**Supplemental Brief Submitted by Appellant for the Hearing
on March 4, 2026**

Plaintiff's Supplemental Brief for Appeal No. 26-001

Permit Holder's Brief for Appeal No. 26-001 Permit No. 2025/09/10/5039

Appeal No. **26-001**

Exhibit A: Illustration of Compromise Solution

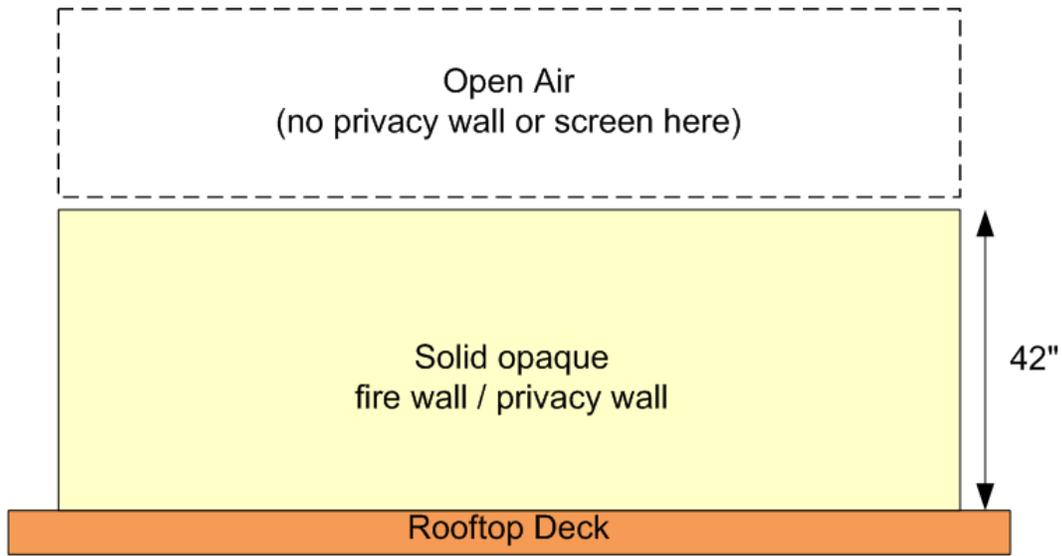
After meeting with the permit holder on 2/22 and 2/24, we agreed to the following compromise solution:

- A solid, opaque fire-rated wall be built along the side of the deck that abuts the property line, up to a height of no more than 42" above the surface of the deck.
- No privacy screen/fence, wall or guard be built above this 42" height.

This compromise solution is illustrated in Exhibit A for clarity. This compromise does not fully meet our requests (i.e. the wall is not transparent, and it is 42" high rather than 30") and therefore does block more light and air than we would like. However, this appears to be the best compromise that can be reached between the parties, and hence **we agree to this**

Exhibit A.2

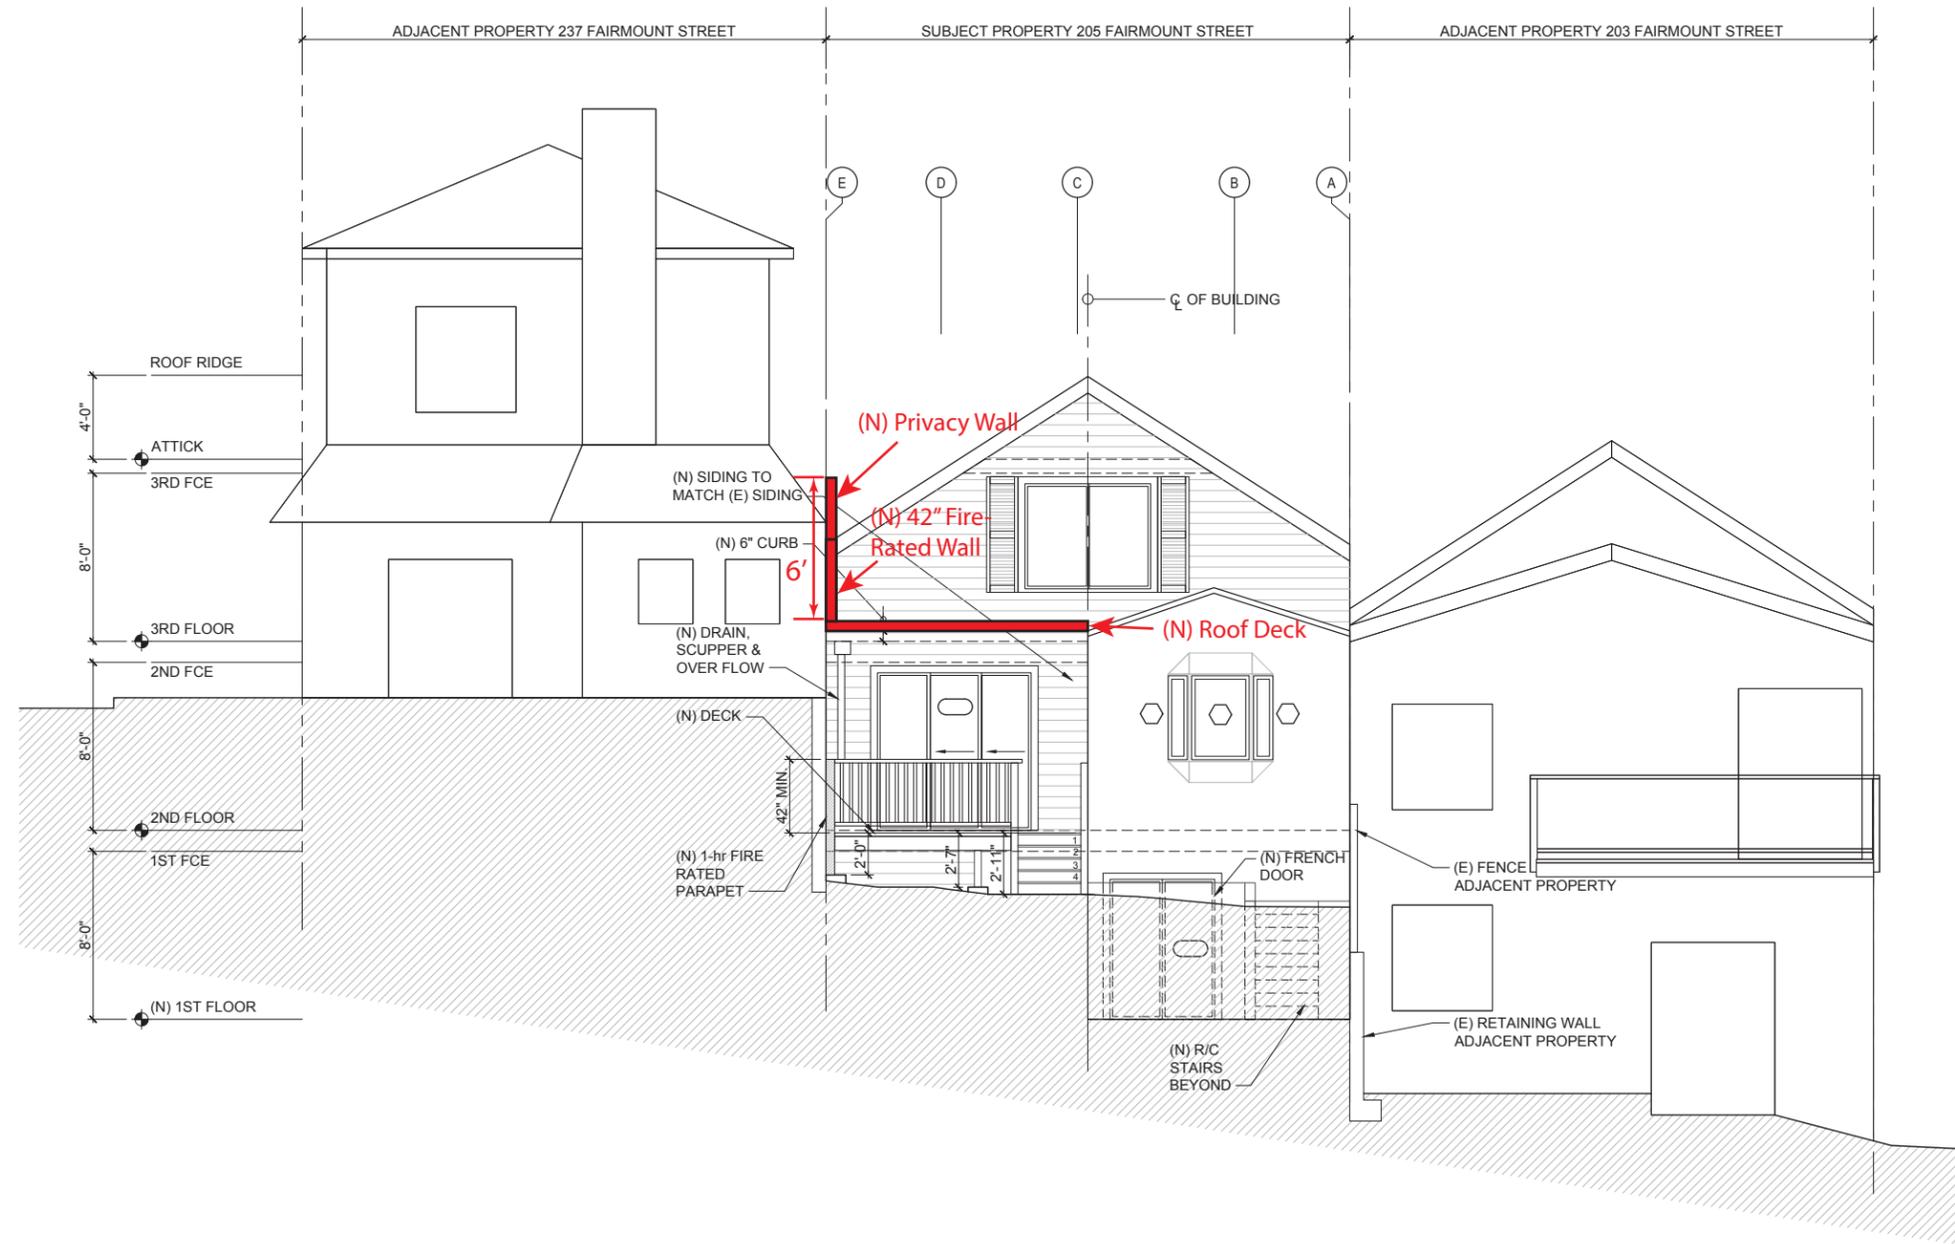
The building plans that were submitted with this permit application show that Mr Guinasso intends to add a rooftop deck on top of a new family room that is currently being constructed at the rear of his house. He also intends to build a 6ft tall solid "privacy wall" along the side of the deck. Since the new family room and rooftop deck are built right up to the property line, this new 6ft wall will also be built directly along the property line. Exhibit A.1 shows the site plan, while Exhibit A.2 shows the rear elevation, with the latest additions highlighted in red.

Our backyard is in the middle of our property, between our house and garage. This new 6 ft wall would be built directly across the only open side of our backyard, as illustrated in Exhibit A.1. The other sides of our backyard are currently bordered by our house, our garage and the fence/tree along the street boundary. Therefore, this new wall would completely box in our backyard. The wall would start at 3ft above the level of our backyard and end up towering at 9ft above, cutting off light and air into our backyard.

Exhibit C: Rendering of Impact of Proposed Wall on Backyard

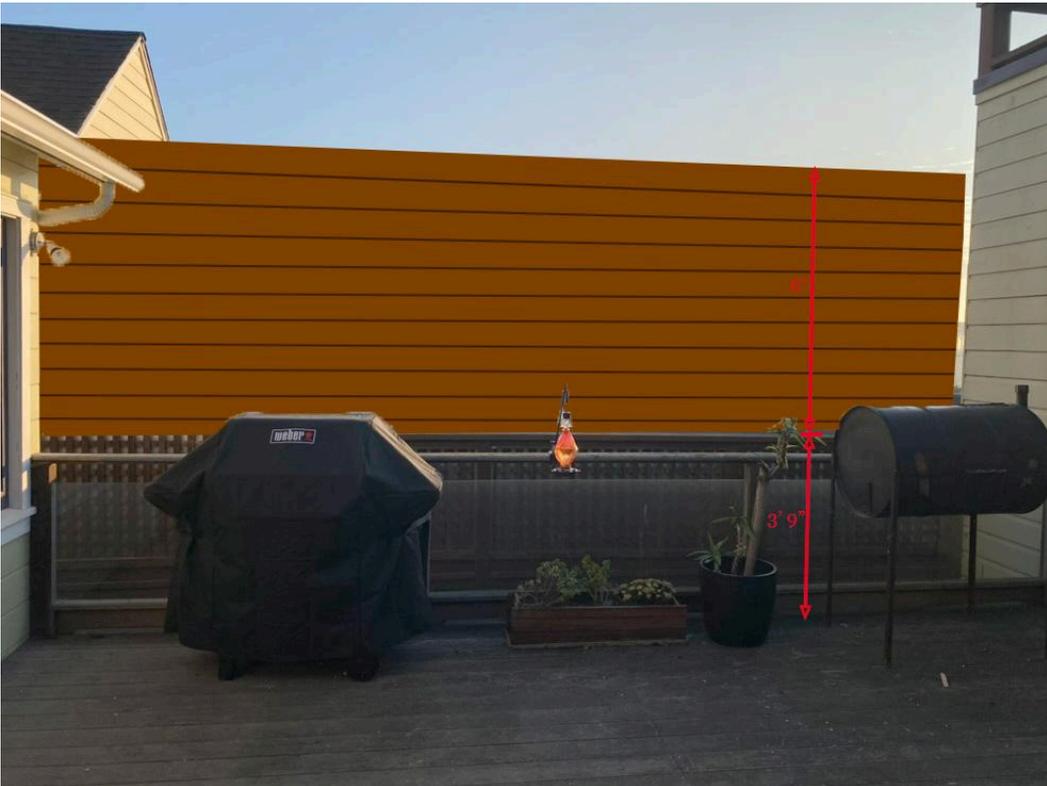
Exhibit B shows what we currently see from inside our backyard. Exhibit C shows a rendering of what it would look like if this wall was built, clearly illustrating the impact

that it would have on our quality of life. The height of the proposed wall in Exhibit C was determined by measuring, with a measuring tape, 6 ft up from the current roof level of the newly built family room, and marking reference points that can be used to accurately draw in the new wall. We will note that we have not been given the opportunity to perform a proper shade study, as we only received notice of this new wall after the permit was approved in late December, and hence this rendering is the best that we can provide given the time constraints.

Exhibit F: Photo Showing Construction along Property Line

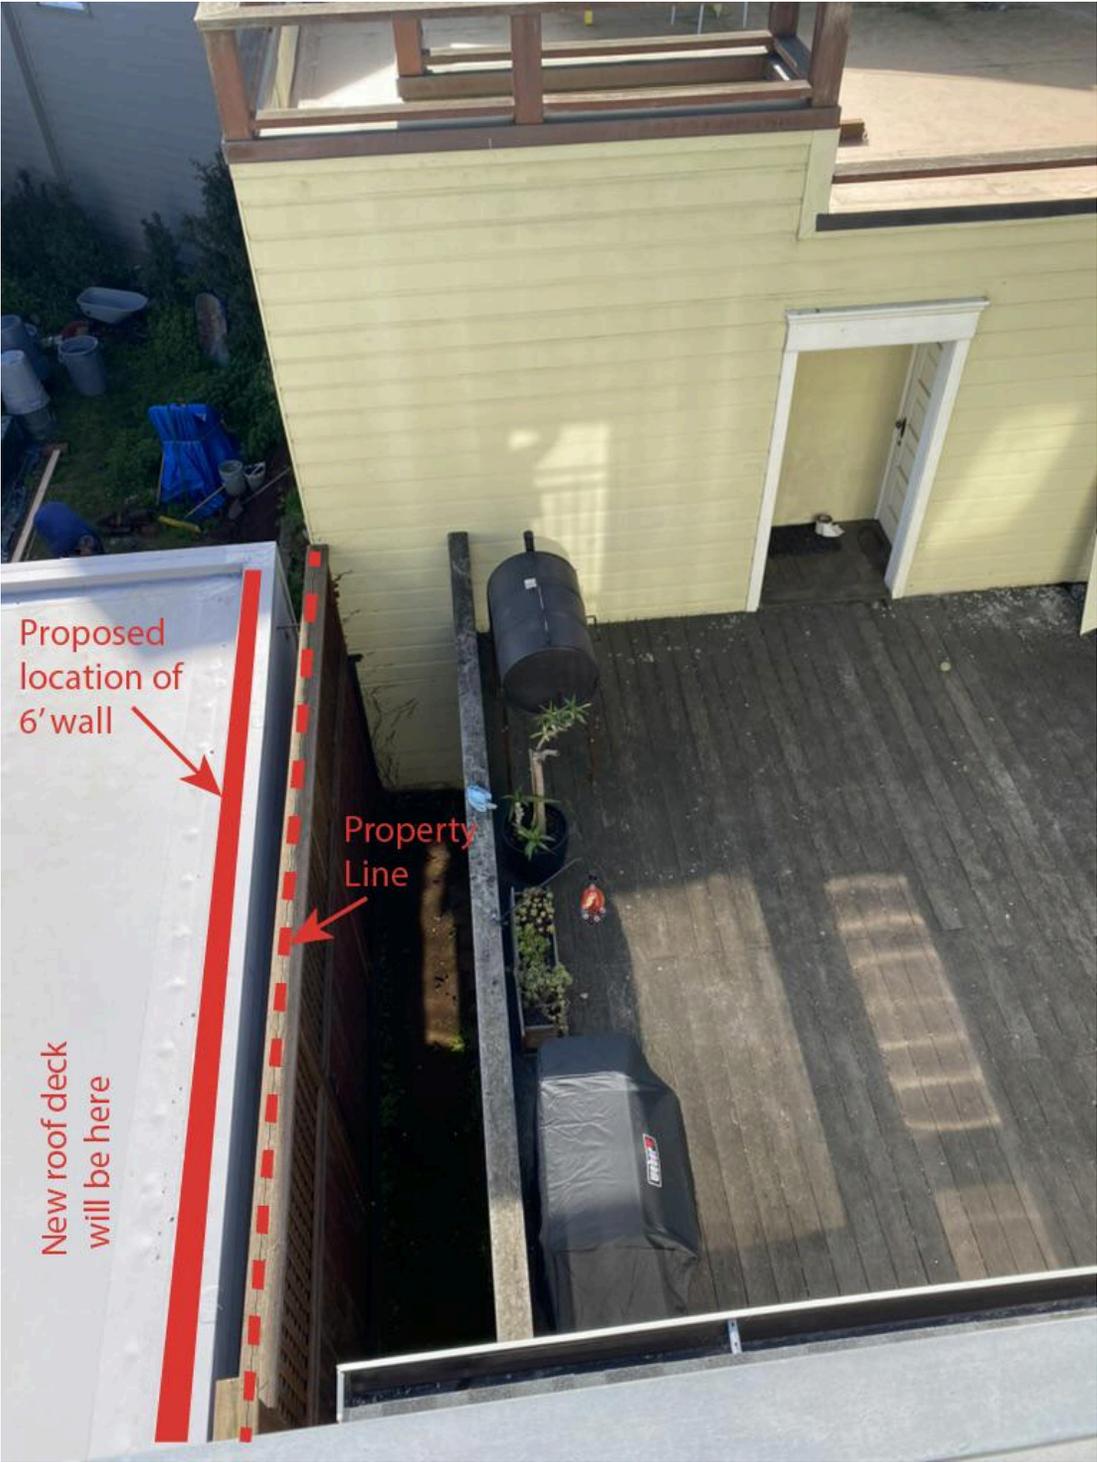
- “Maintain light to adjacent properties by providing adequate setbacks” (Design Principles, pg. 5).
 - Exhibit F shows that the new family room, rooftop deck and 6ft wall are all built within inches of the property line that we share with 205 Fairmount St.
 - Exhibits C and E show renderings of the result of how this wall would close off the only open side of our backyard and block the light into our backyard and kitchen.
 - If the deck was appropriately set back from the property line, the need for a firewall could be avoided, and a simple railing could be installed that would not block our light and air.
- “Guideline: Articulate the building to minimize impacts on light and privacy to adjacent properties.” (Rear Yard section, pg. 16). The guidelines further state on that page that “When expanding a building into the rear yard, the impact of that

4 PARAPET / GUARDRAIL DETAIL
SCALE: 1 1/2" = 1'-0"

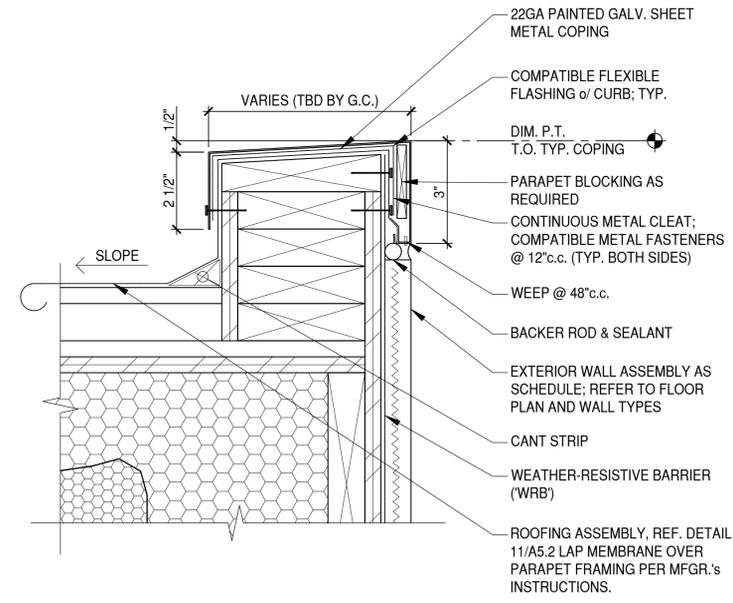
There appeared to be some confusion about the height of the proposed wall along the side of the rooftop deck that abuts the property line. The plans that were submitted with the permit application show a 42" tall firewall, as well as a privacy wall. Both the plans, and our renderings of how the wall would impact us, showed the privacy wall to have a height of 6' above the surface of the deck. It was this 6' tall wall that we were appealing. There was never any proposal to build the privacy wall an additional 6' above the 42" firewall. The confusion may have been caused by the plan that the 42" tall firewall and 6' tall privacy be built as a single wall that extends 6' above the deck height. This point is mostly moot now, as we have agreed with the permit holder to limit overall wall height to 42".
